# 66104A-08

## S E R V I C E N O T E

### 66104A DC Power Supply

**The instrument will not communicate or will not complete self test.**

**Diagram A:** ROM not fully inserted

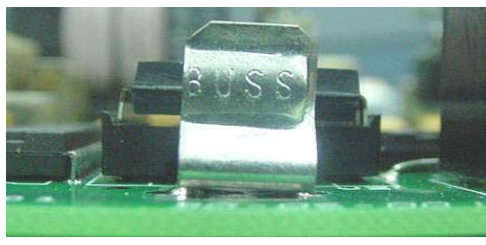
The Programmed ROM P/N 5080-2529 (Circuit Reference “U2”) See [Figure 1](#).below for the location of “U2”. When the ROM “U2” is not inserted correctly See [Diagram “A”](#) for details, the instrument may exhibit the following faults:

These faults could also occur if the ROM or the socket is intermittent due to dirty or contaminated pins.

1. The instrument will not turn on
2. All of the segments on the Front Panel display are not light.
3. The instrument will fail self test or will not boot-up.
4. The instrument will not communicate & can not be calibrated.

The ROM “U2” should be removed from the socket. (See [Figure 1](#)). The socket and the ROM should be inspected for contamination or other defects. The ROM is a ceramic part and can be damaged or broken if too much force is applied when reinstalled. [Diagram “B”](#) shows the ROM “U2” inserted correctly.
